DRAWING TITLE: **REVISED FINISH SCHEDULE (A142R, A143R)**
 PROJECT NAME: **WAYNFLETE LOWER SCHOOL ADDITION & RENOVATIONS**
 360 SPRING STREET / PORTLAND, MAINE 04102

DATE OF ISSUE: **FEBRUARY 16, 2017**
 DESCRIPTION: **ADDENDUM #3 - POST**
 SCALE: **NTS**
 PROJECT NUMBER: **2013-0050**

REVISION 1: ADDENDUM #4 31 MARCH 2017

SKA-09
22 Feb 2017
MOTORIZED SHADE
CLARIFICATION
p 2 of 2

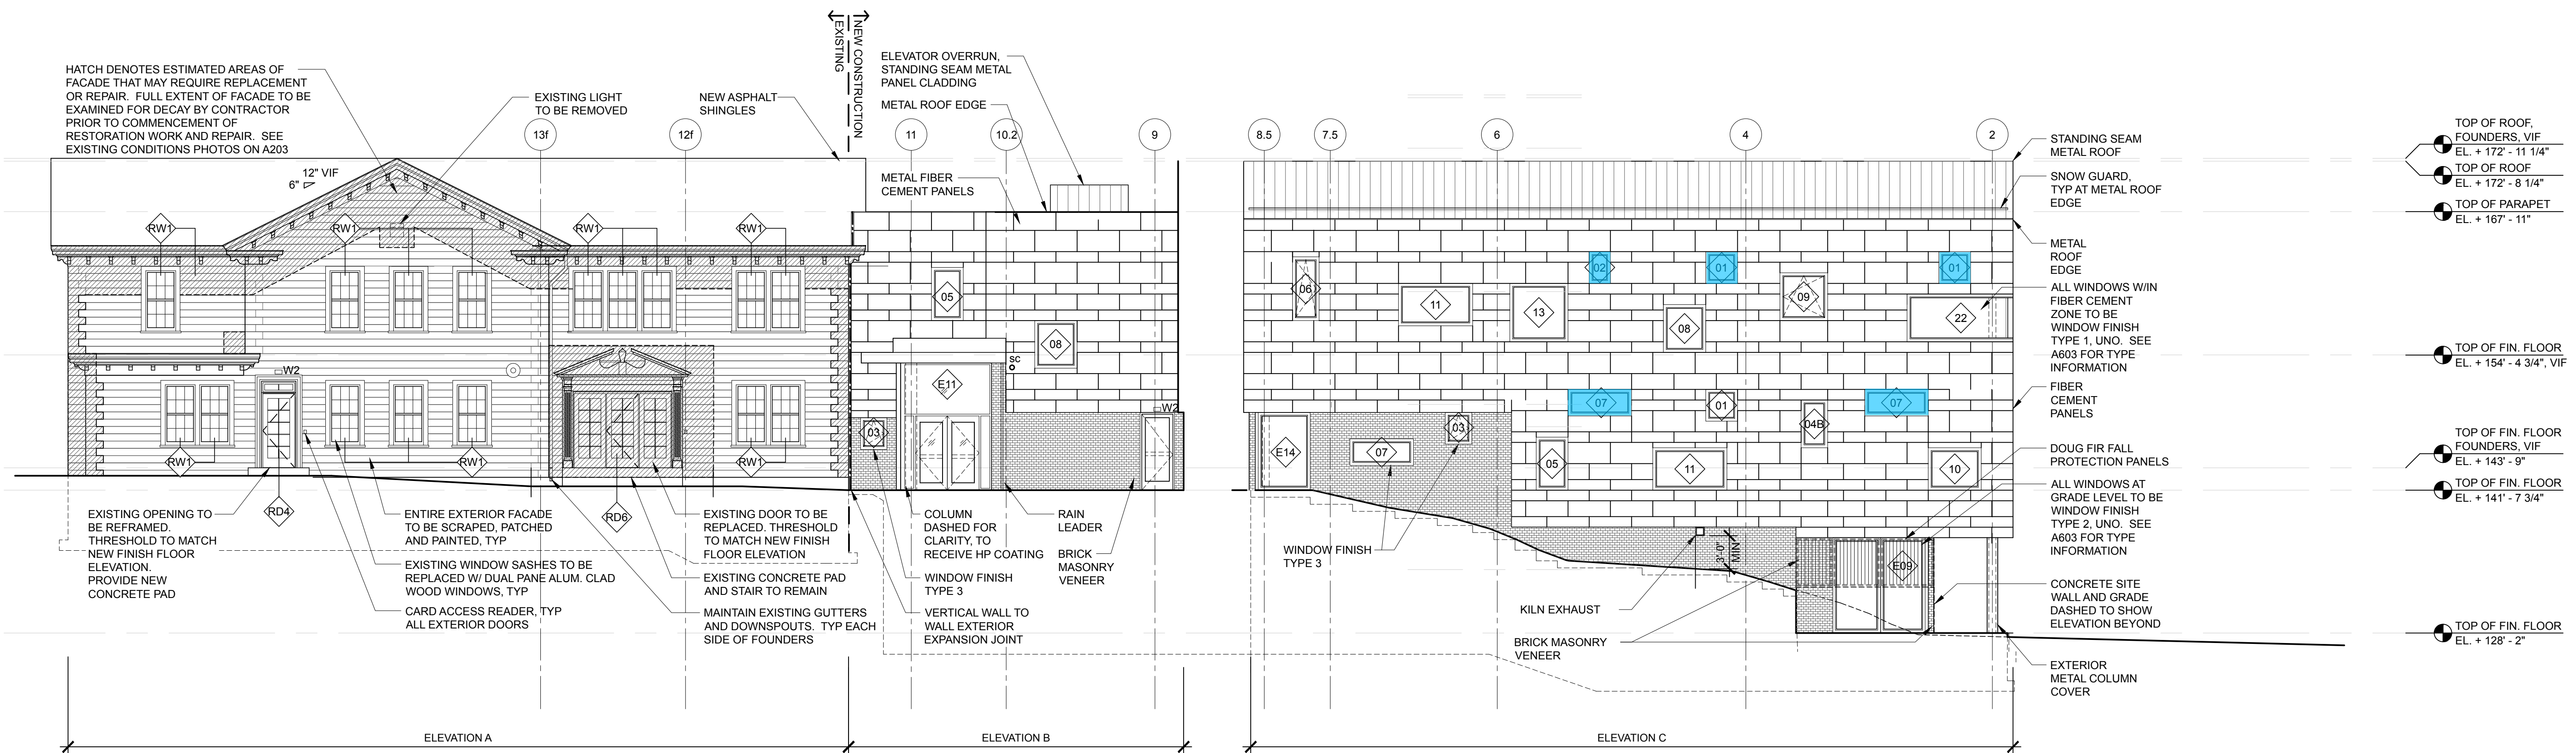
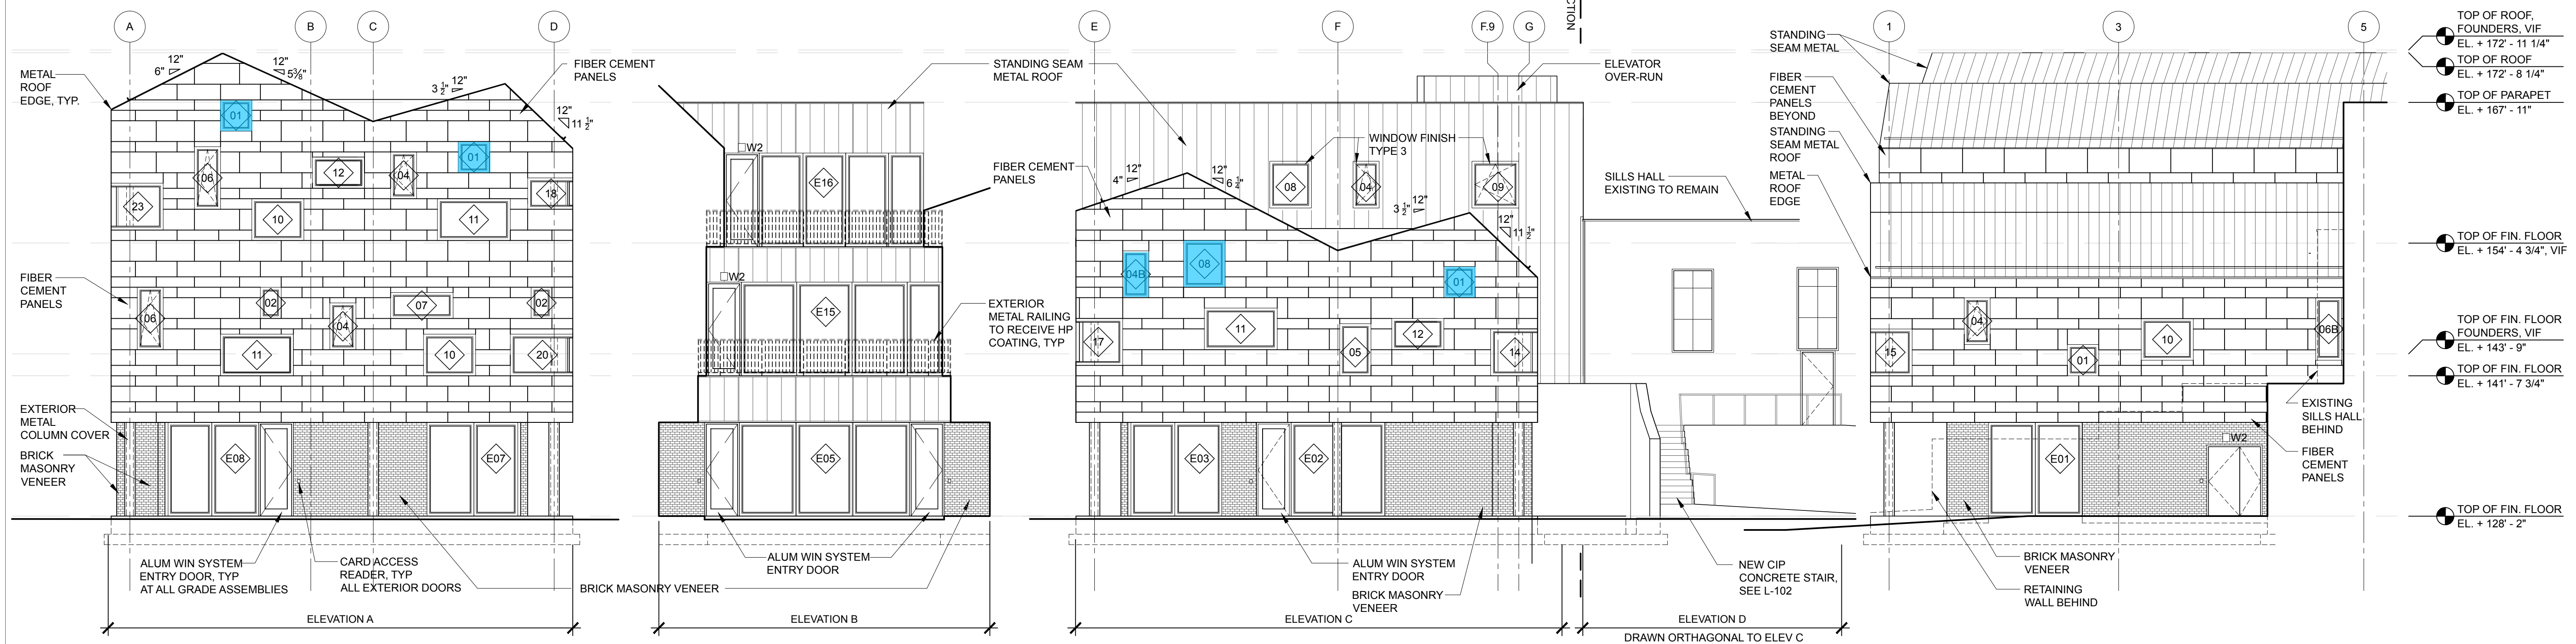
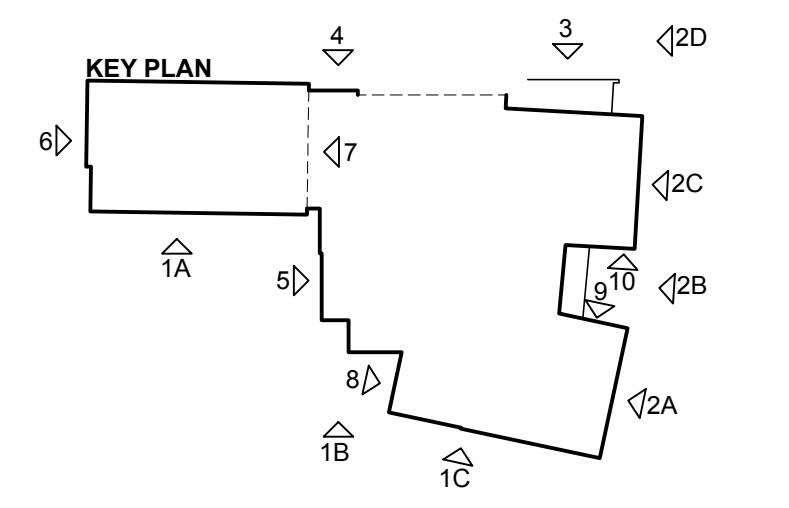
**BATTERY
OPERATED
MOTORIZED SHADE
LOCATION**
